RE: DRAINAGE REPORT SUBMITTAL OF AMBER PLACE SUBDIVISION
RECEIVED MARCH 7, 1986 FOR PRELIMINARY PLAT AND GRADING
PERMIT APPROVAL (G-13/D12)

**DRAINAGE REPORT FOR
AMBER PLACE SUBDIVISION**

**January, 1986
Revised March 1986
per Hydrology Comments**

TITLE: AMBER PLACE SUBDIVISION
OVERALL GRADING, DRAINAGE & PAVING PLAN

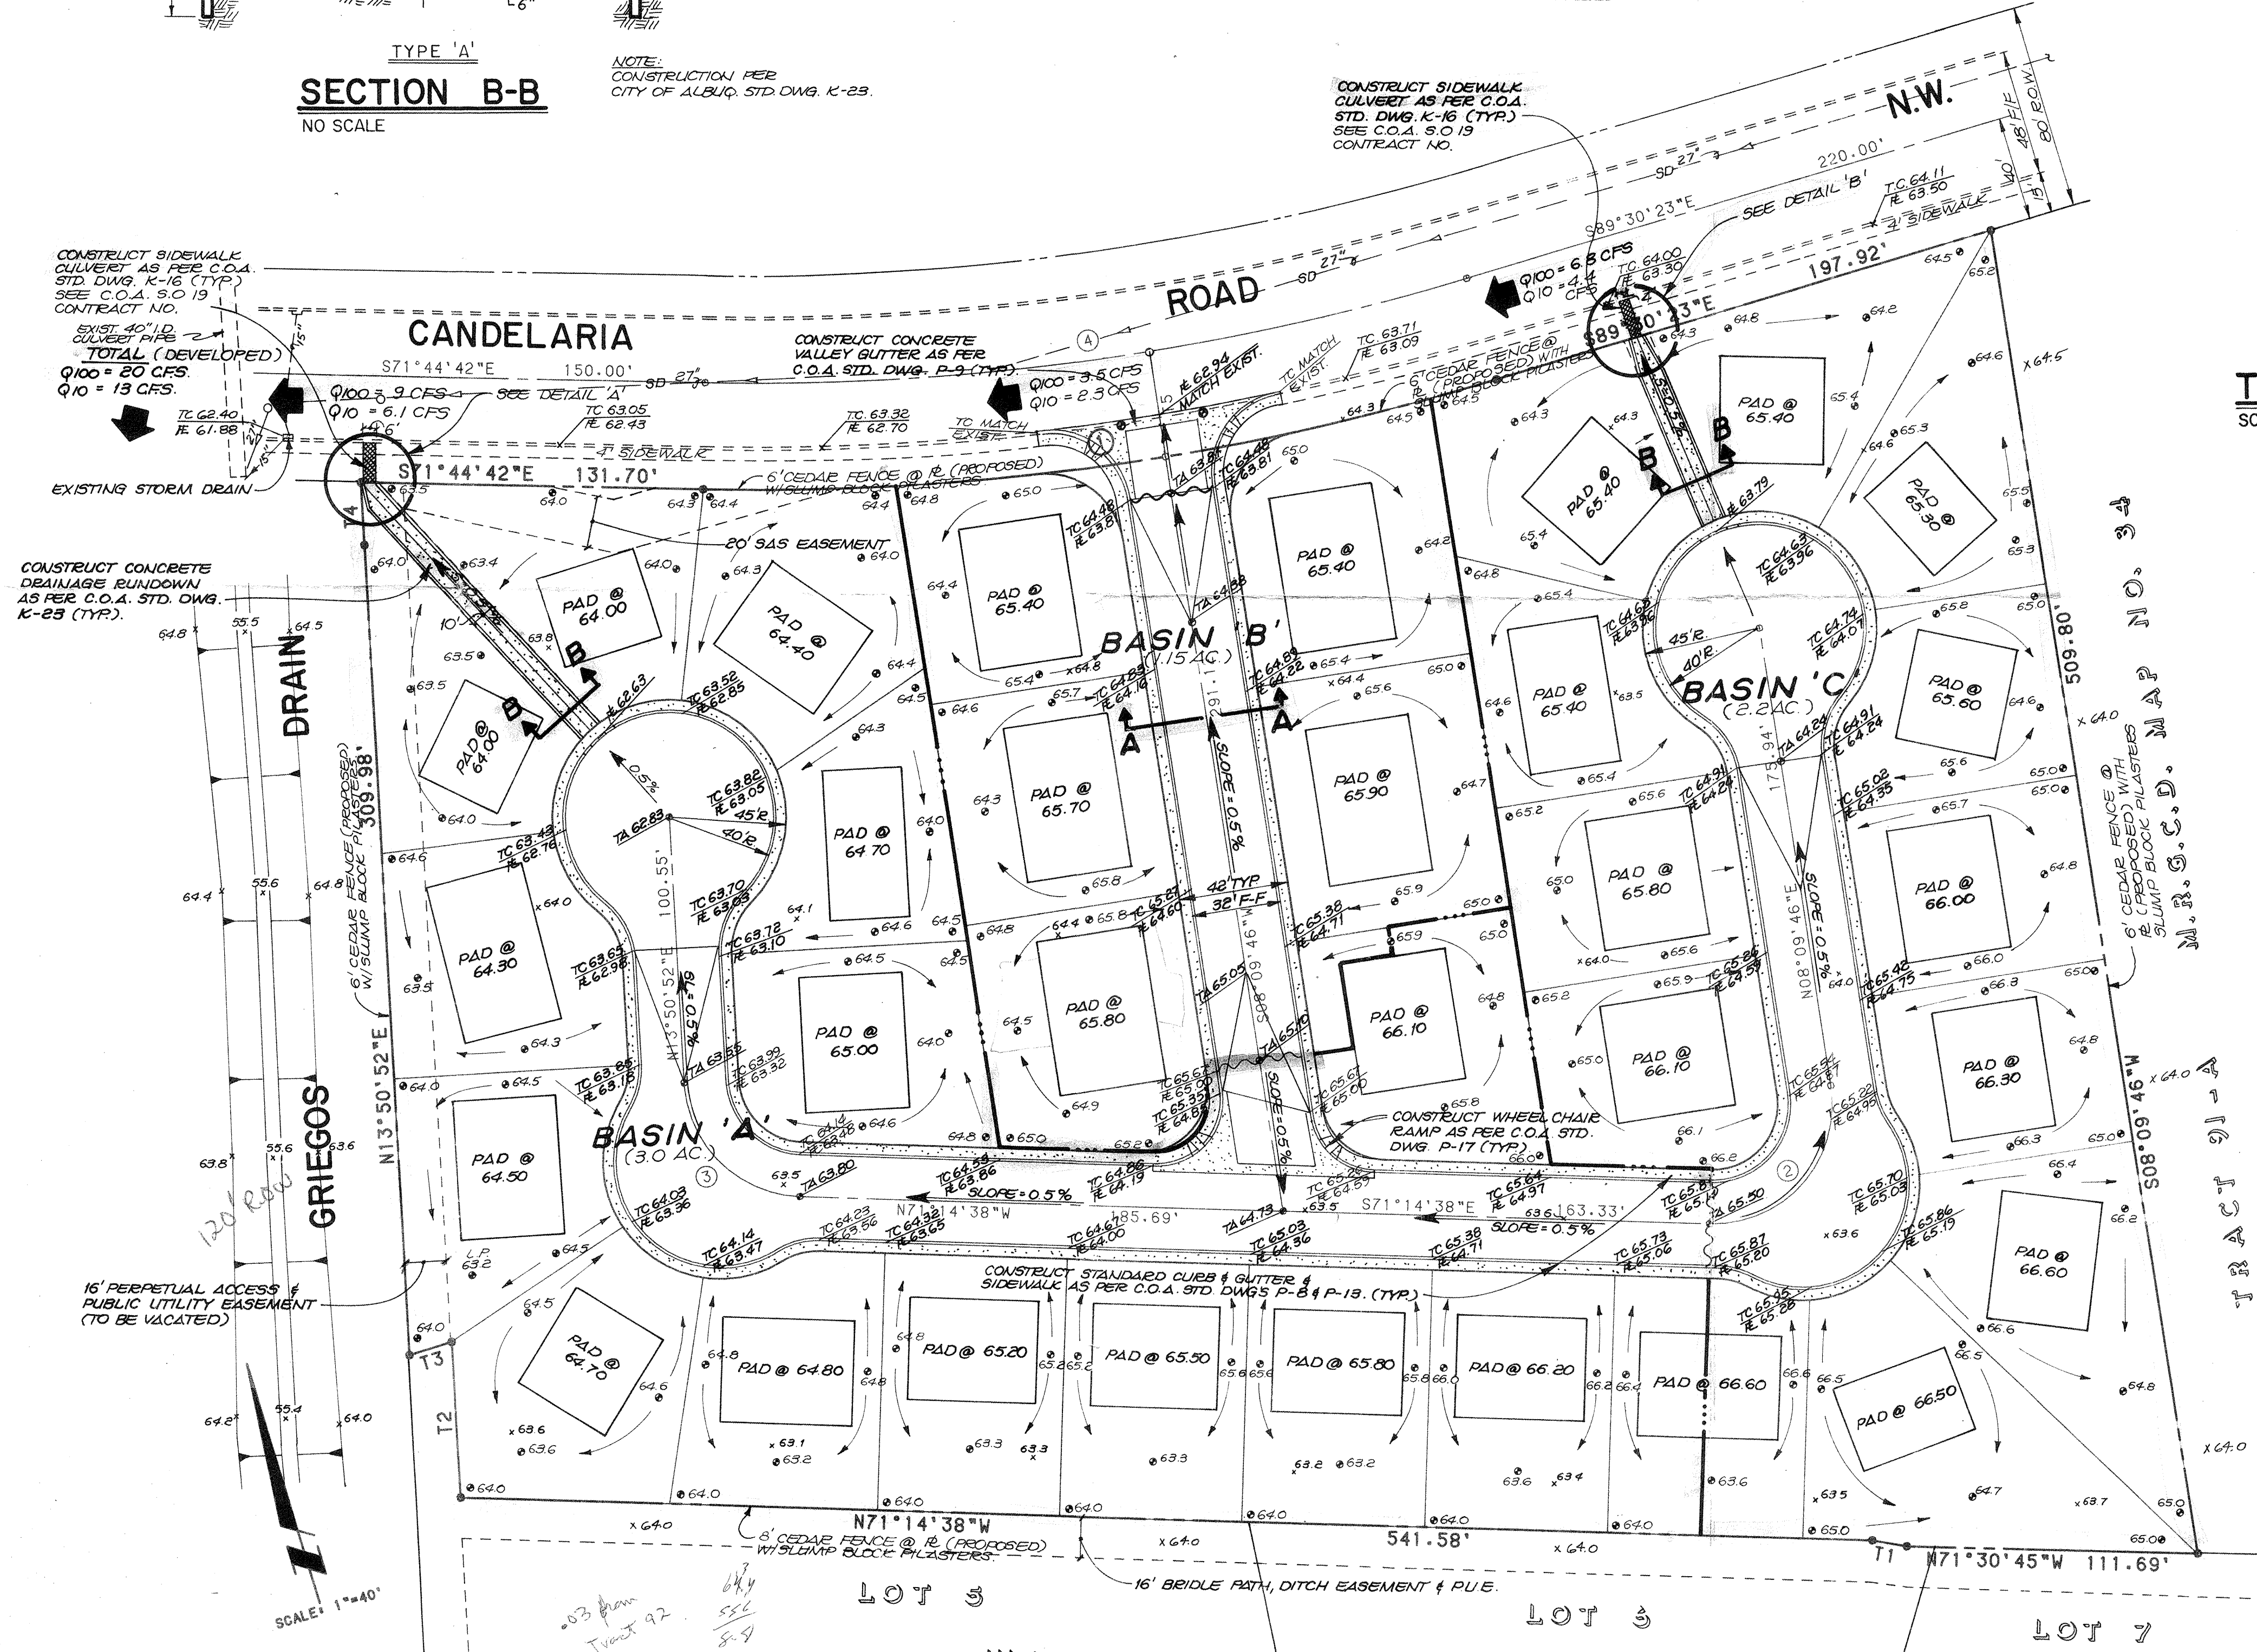
The Grading Plan for Rough Grading Permit can be approved after Preliminary Plat is approved by DRB. If desired, bring in the mylars of the Grading Plan for Hydrology's approval signature. A Topsoil Disturbance Permit will be required from Environmental Health and should be noted on drawings.
